DeKalb County Historic Preservation Commission

Staff Report

- O. 1020 Springdale Road, Lena Murphy. Construct a rear addition, enclose rear porch, install a pool, patio, and fence in rear yard. **1246928**

HISTORIC SITE PLAN

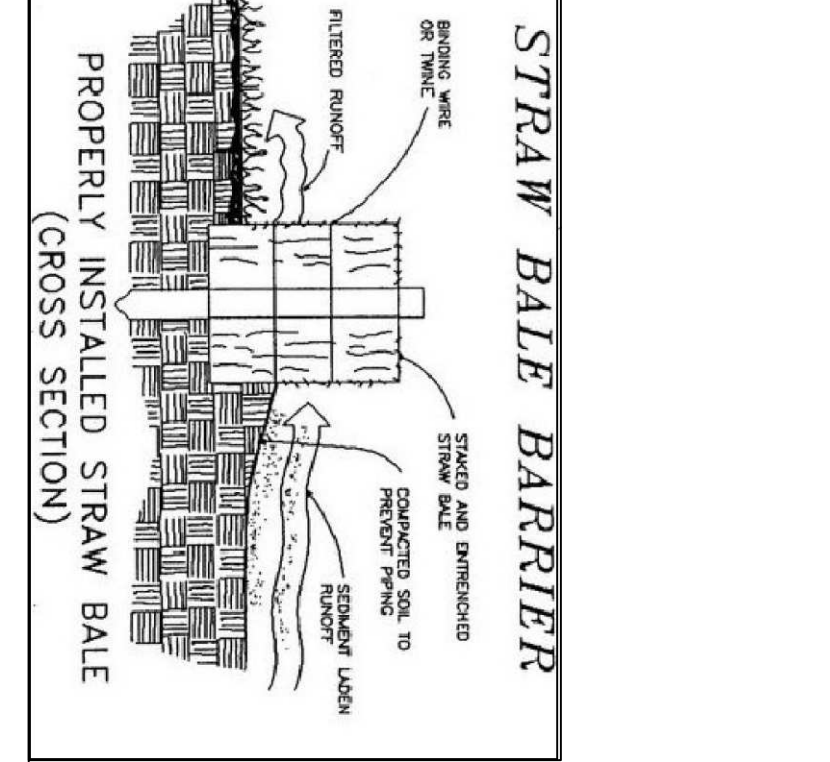
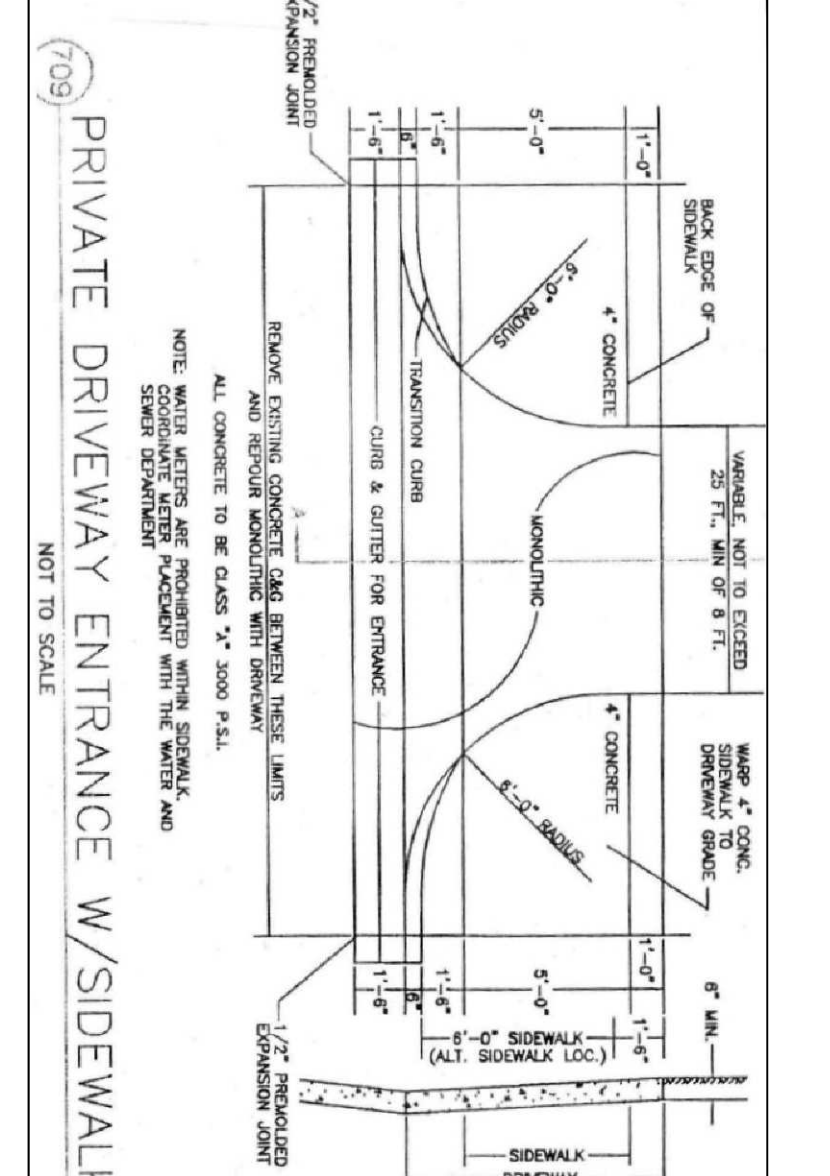
1. On the site plan, please show the distance the pool is from The By Way right-of-way.
2. How tall will the pool fence be and what will it look like?
3. Is the rear wing an addition?

The zoning code setback on The By Way side of the property is 35' rather than the 8.5' shown. This will not affect the historic preservation review but if the pool is less than 35' from the right-of-way, it will affect your building permit review. If the distance is less than 35' you may apply for a variance to decrease the required distance, but approval is not guaranteed. The granite wall may project into the setback without a problem.

No, my mistake, the setback was incorrect on the original plan we submitted, so when I adjusted the setback to be 35' along right of way of "Byway", the pool was already at 34.99', so I moved pool it 0.01' to make it 35' from the right of way of Byway.

The perimeter fence does not work for our requirements, We have to have a fence closer to the pool with auto locking-child proof gates.

On this revision, I sort of squared the pool off with the house and place 2 gates with the childproof -auto locking along each line for access.
